Statutory Comments (07/10/2025)

Your ref: LCC/2023/0030
Our ref: LCC.D2.2023.0030
Date: 7th October 2025

Application no: **LCC/2023/0030**

Address: **Land off Bourbles Lane, Preesall**

Job No:	220503	Drawn By:	J.L.
Date:	Feb 2024	Checked By:	J.L.
Scale:	1 / 200 @ A1	Drawing No:	220503 / 03 / C

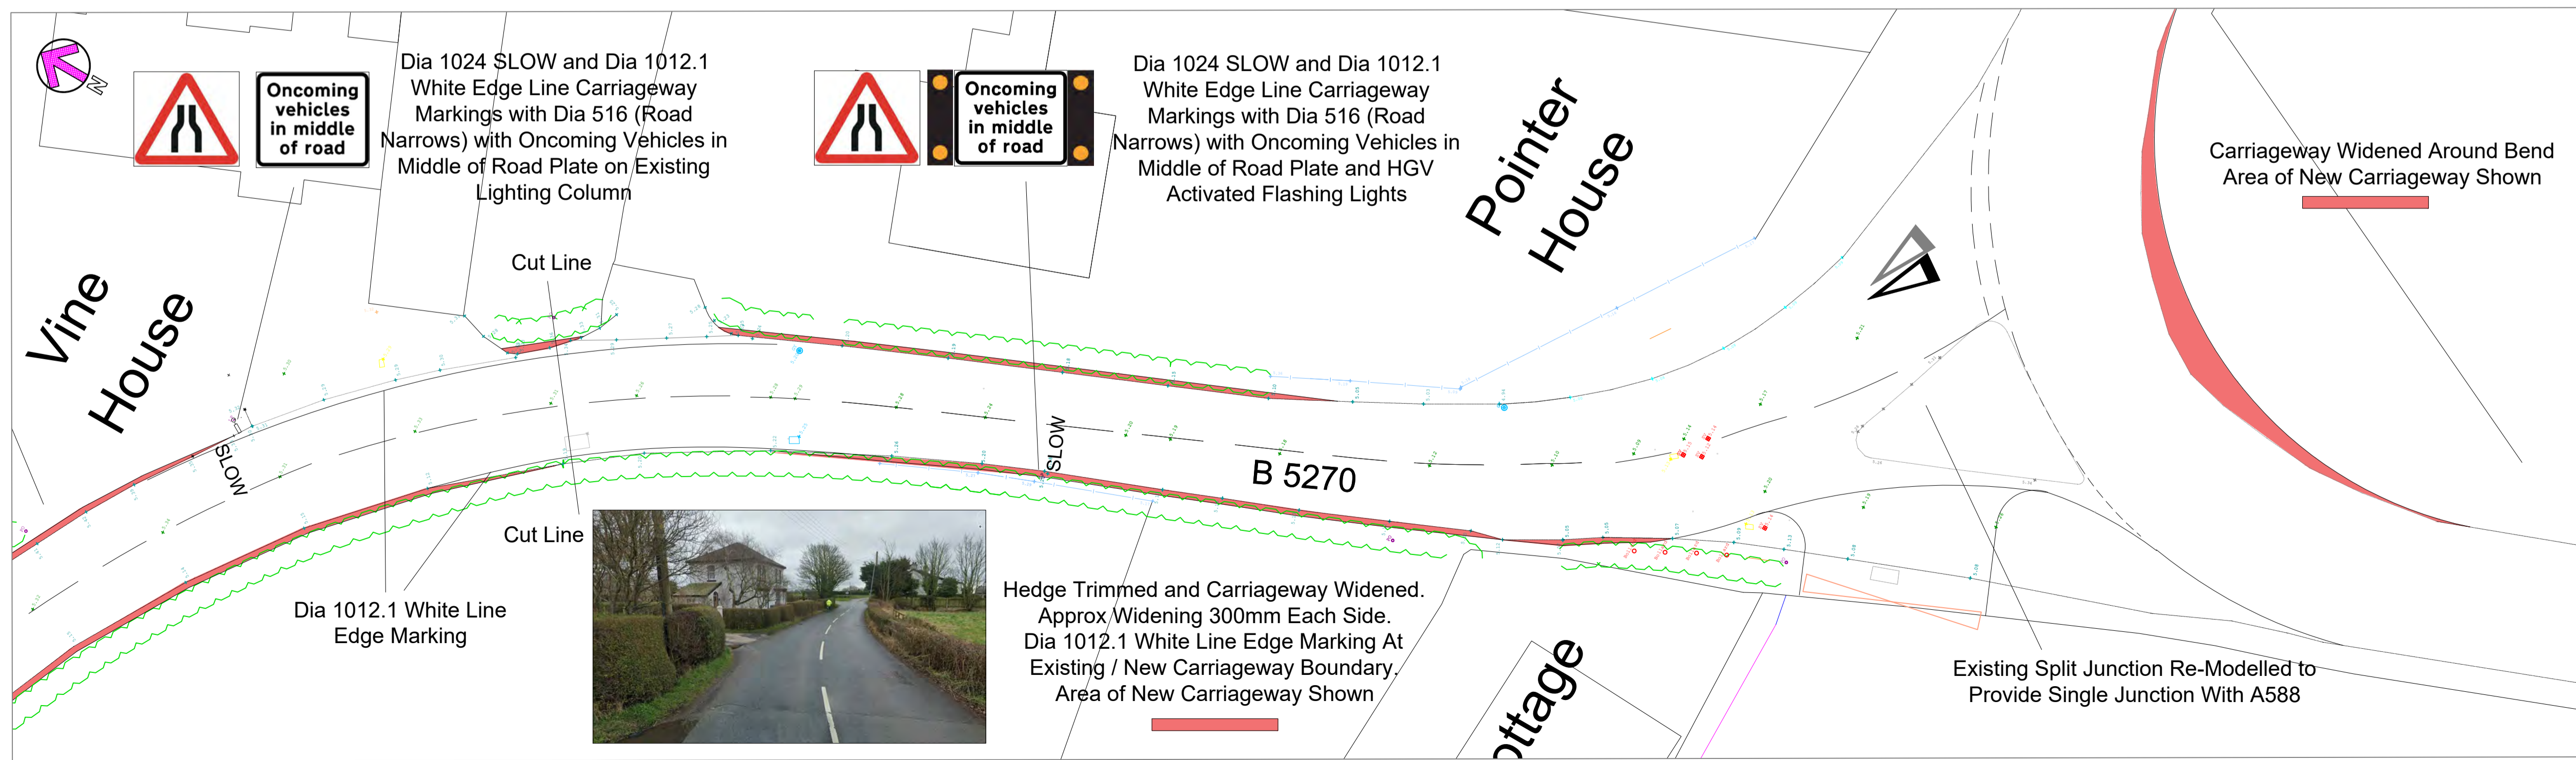
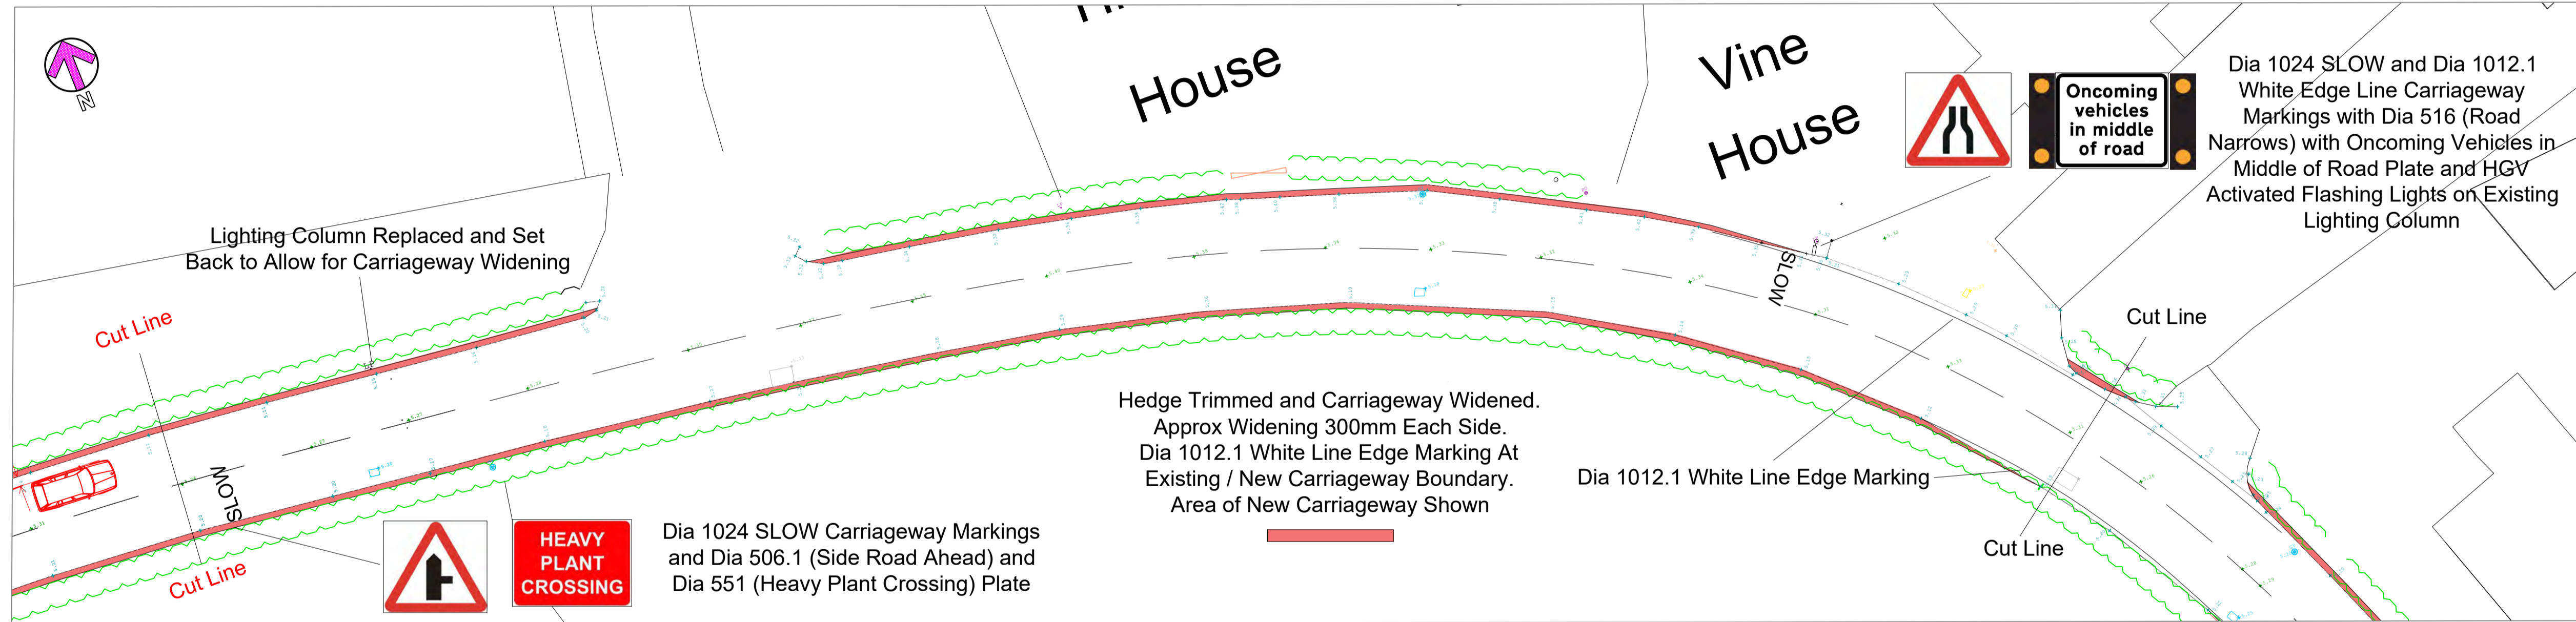
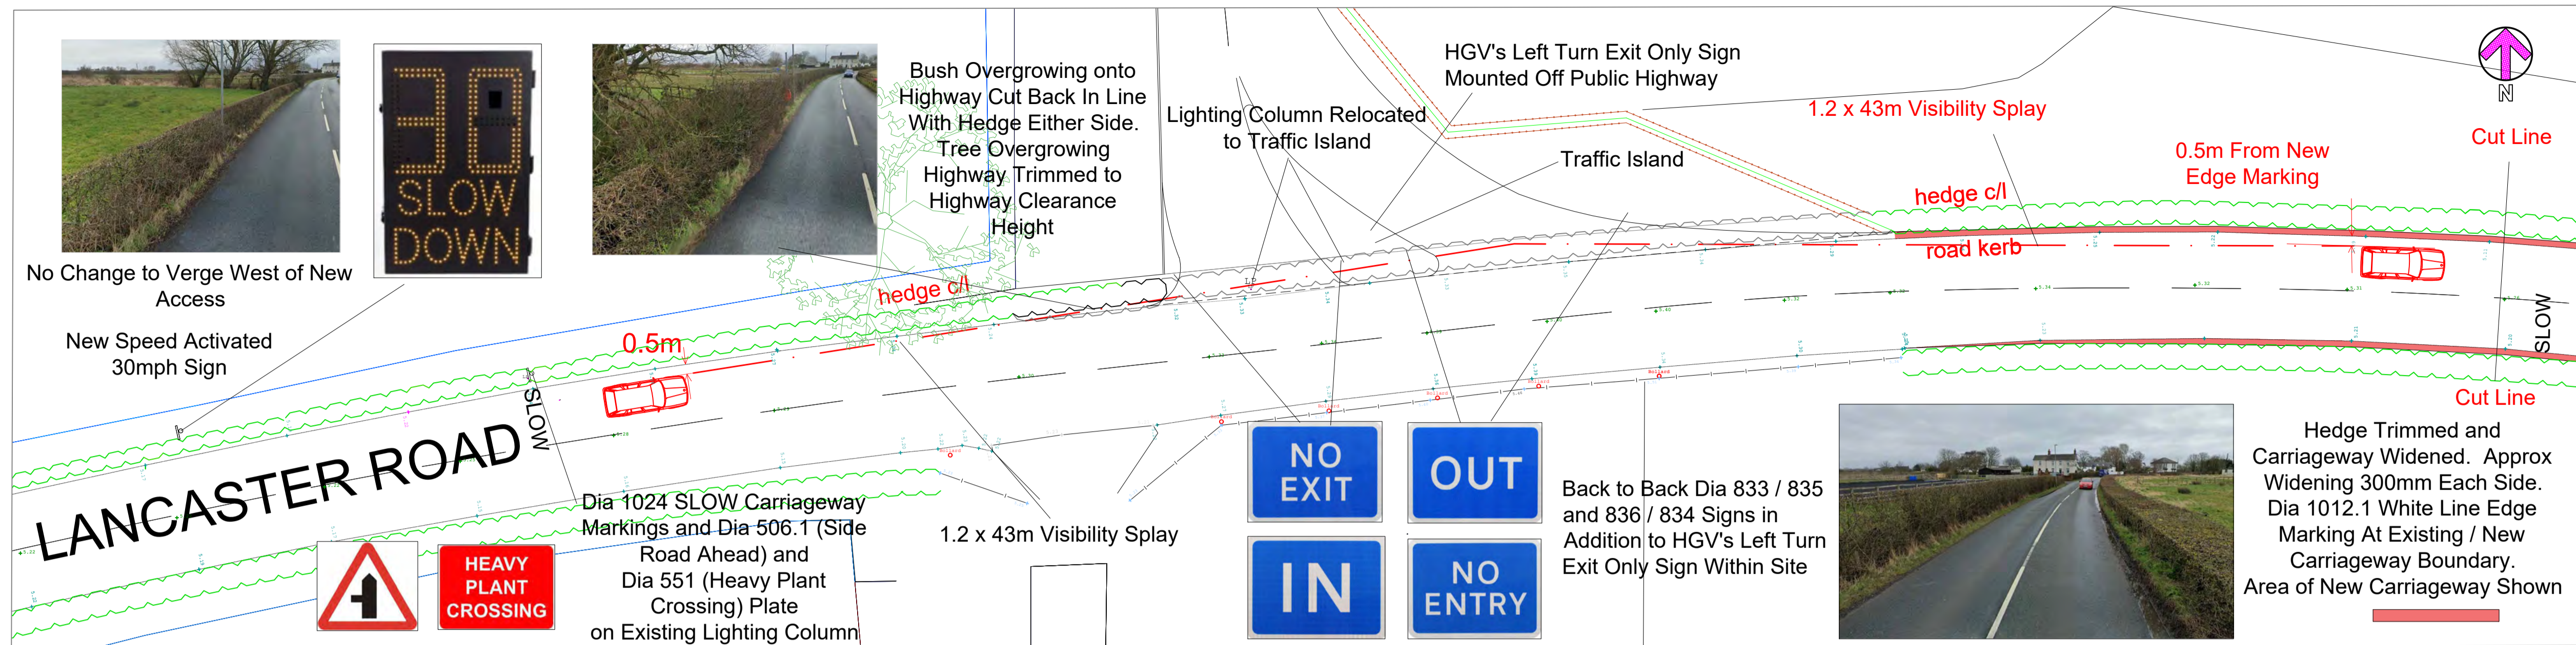
The Agent within the TS has provided Turner Lowe drawing number 220503/03/C titled "Highway Works," which aims to widen the carriageway by 0.3m on both sides (where possible, see note below). This is by using the available verge which is the distance between the edge of the carriageway and the start of the hedge (root stock). Currently, Lancaster Road is a single carriageway road where widths are generally around 5.5m (it is important to highlight that the existing road isn't straight and greater carriageway width is needed to satisfy swept paths of larger vehicles), without footways and where verges exist which are variable in width, are less than 0.5m wide. At this stage no survey has been undertaken to evidence base what can be delivered.

The LHA also question the feasibility and deliverability of the proposed carriageway widening. This is because of the following:

- **Variable hedge stock width-** The root stock of the hedge is variable and so there is an element of risk that the available highway width is less than advertised on the submitted plans. This is without further investigations being undertaken. Therefore, there is an element of risk that two-way HGV movements along Lancaster Road

These concerns include the feasibility of widening Lancaster Road, and the LHA note that no amended swept path drawing has been provided to demonstrate that full vehicles, including articulated HGVs with wing mirrors, can safely pass each other within the carriageway including a suitable factor of safety between vehicles and edge of carriageway. Without this evidence, the LHA do not support the assertion that two-way movements can be safely accommodated, and based on the current submission, it appears this is not achievable. Notwithstanding the issue of significance on vulnerable road users.

The Agent has recognised that two-way HGV movements are not possible and so has proposed that a signage scheme will be implemented in this location, as shown on Turner Lowe drawing number 220503/03/C titled "Highway Works" and described above.

This drawing does not indicate that such a scheme would be effective and there are also concerns associated with the location of the proposed signage given the existing highway constraints, which will be discussed later in this section.

Job No:	220503	Drawn By:	J.L.
Date:	Oct 2024	Checked By:	J.L.
Scale:	1 / 200 @ A1	Drawing No:	220503 / 04.1 / A

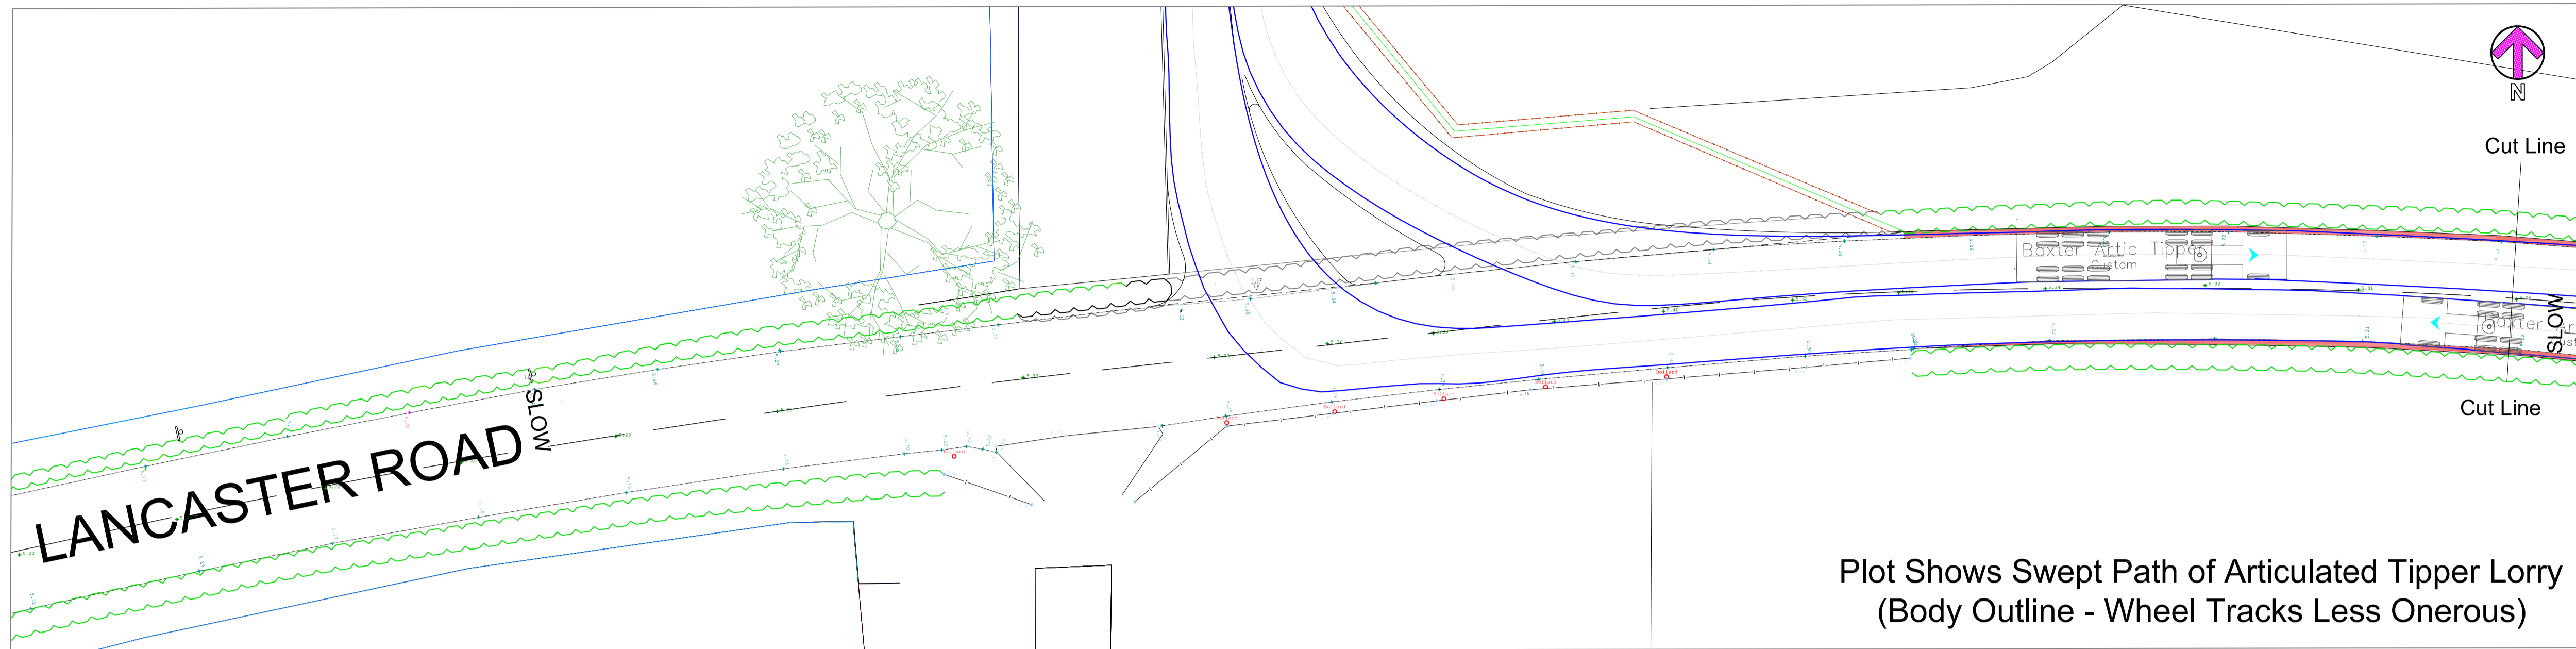
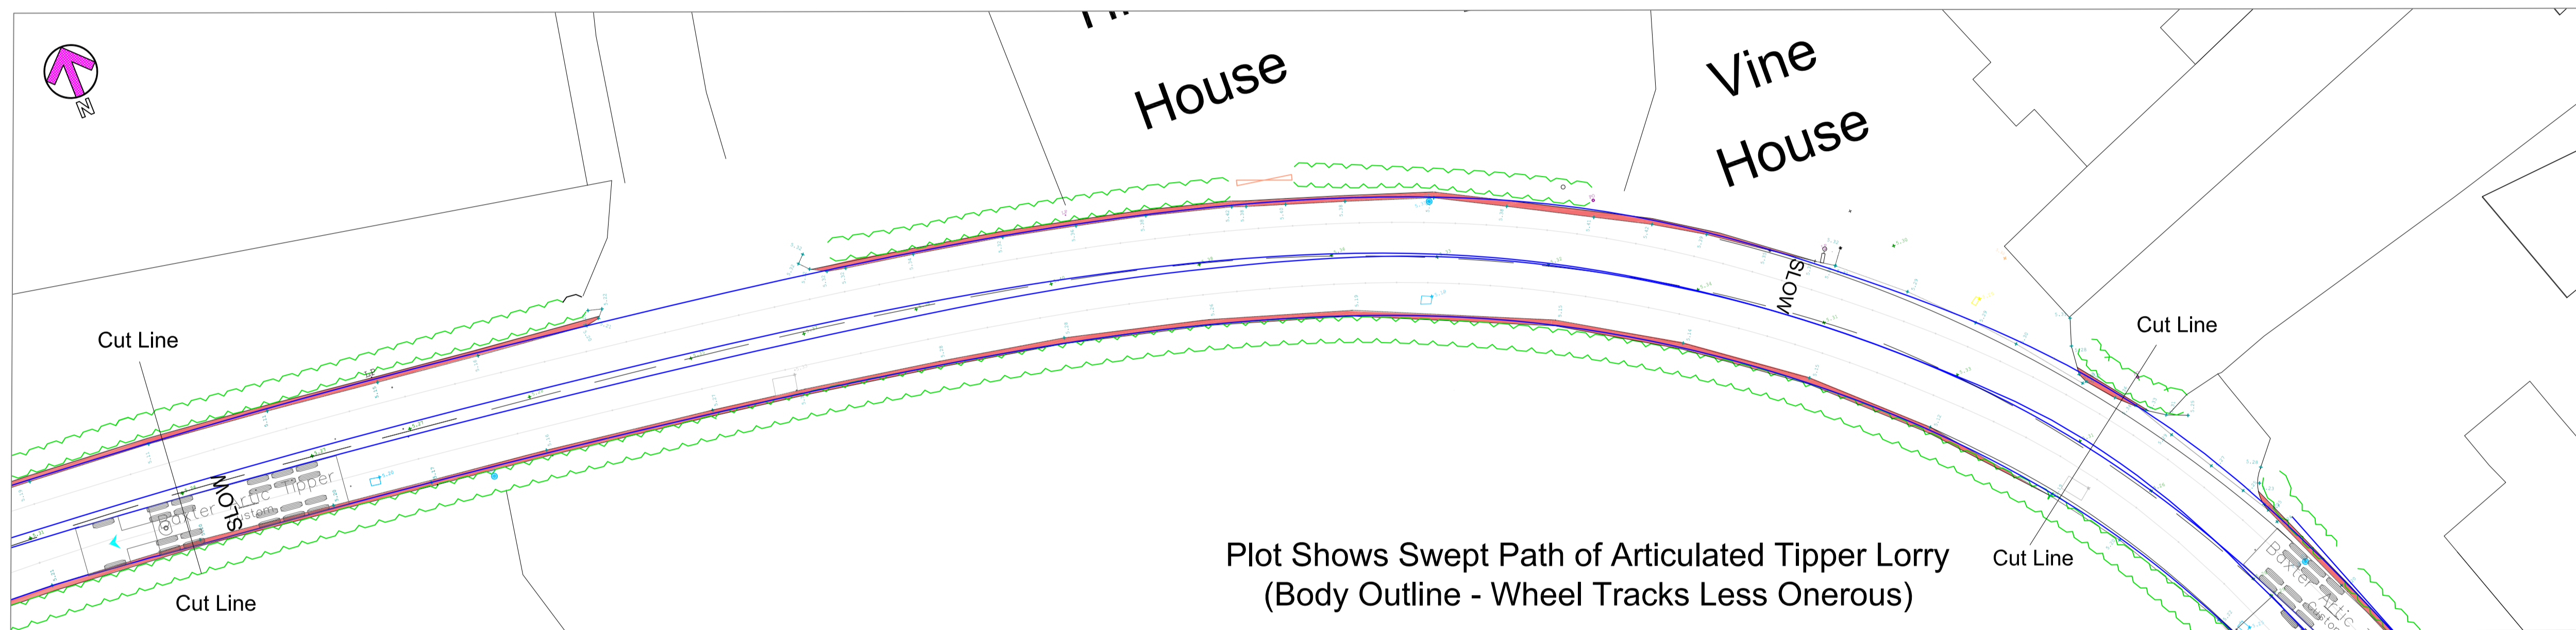
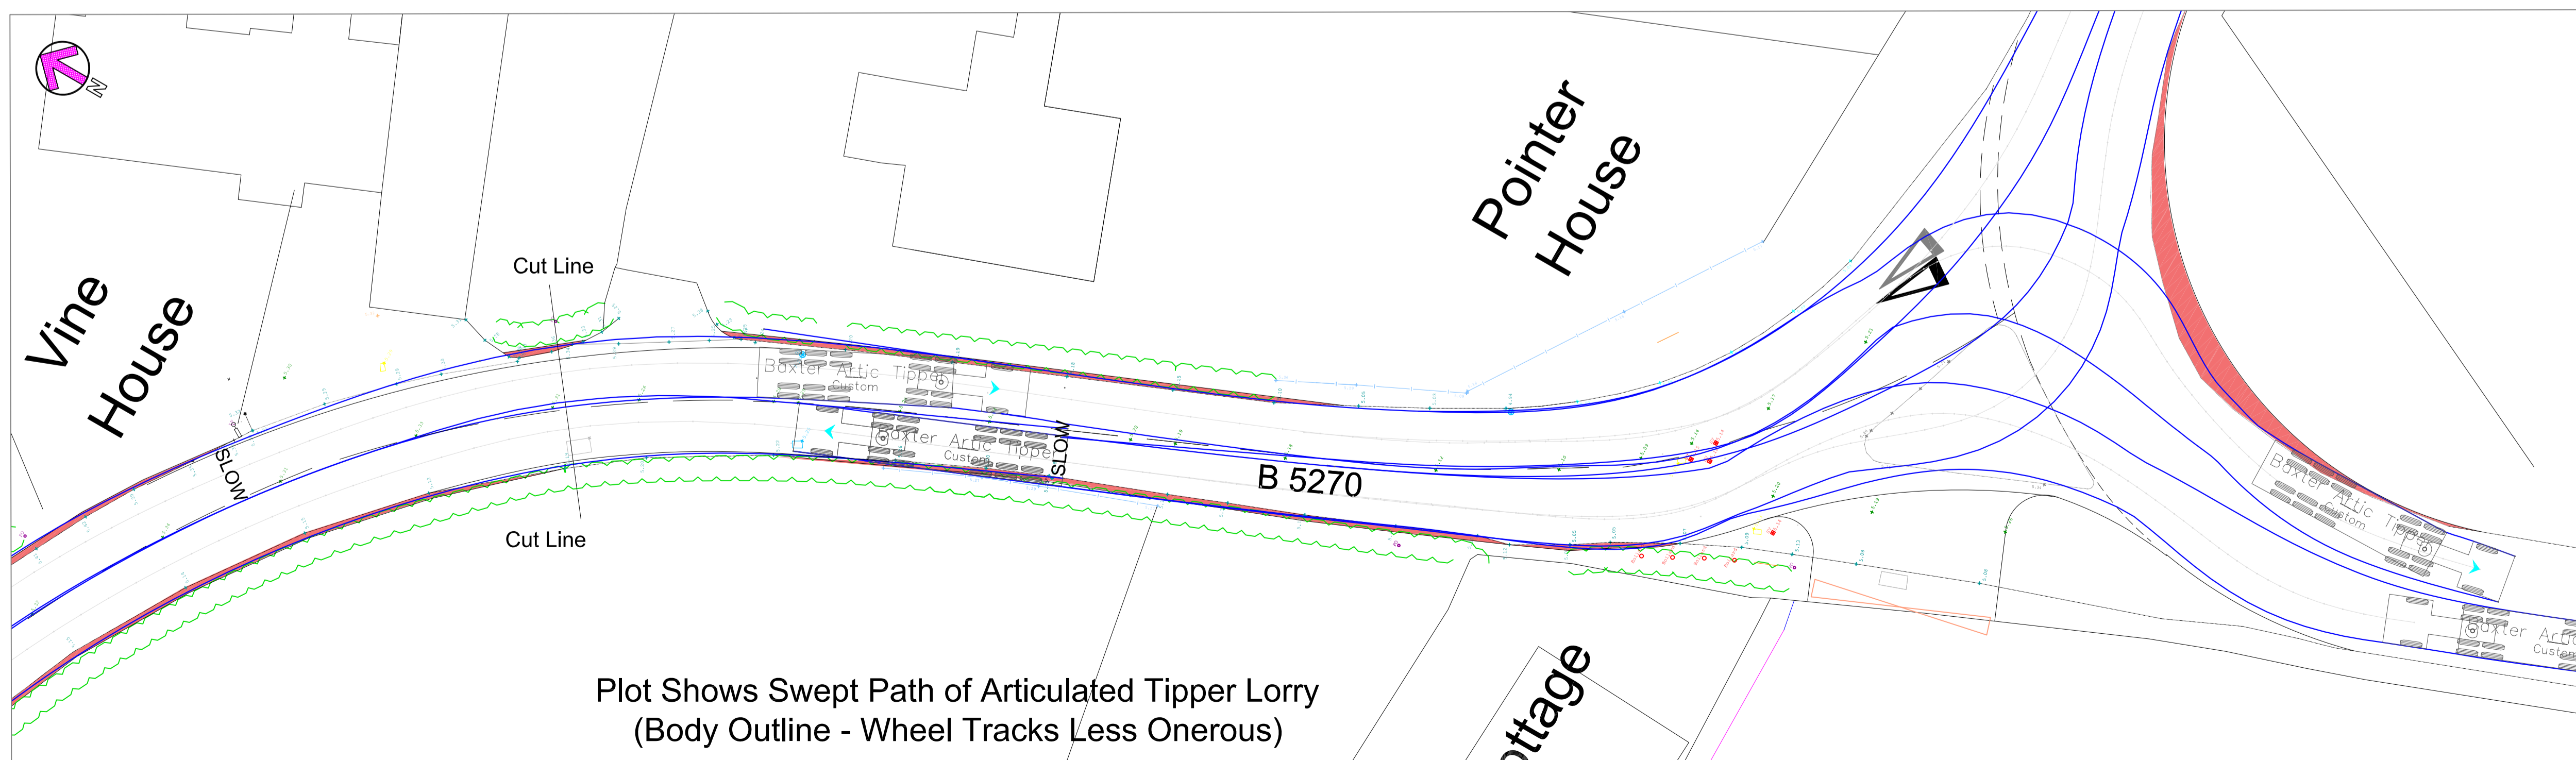
The Agent has provided Turner Lowe drawing number 220503/04.1/A titled "HGV Manoeuvres Sheet 1" and Turner Lowe drawing number 220503/04.2/A titled "HGV Manoeuvres Sheet 2." Within the TS, the Agent states in paragraph 4.12, that "*with the widened carriageway, there would be clearance between 2 HGV's passing over virtually all of the length of Lancaster Road from the site access to the A588. The exception is the bend at Vine House.*"

The Agent has provided Turner Lowe drawing number 220503/04.1/A titled "HGV Manoeuvres Sheet 1" and Turner Lowe drawing number 220503/04.2/A titled "HGV Manoeuvres Sheet 2." Within the TS, the Agent states in paragraph 4.12, that "*with the widened carriageway, there would be clearance between 2 HGV's passing over virtually all of the length of Lancaster Road from the site access to the A588. The exception is the bend at Vine House*".
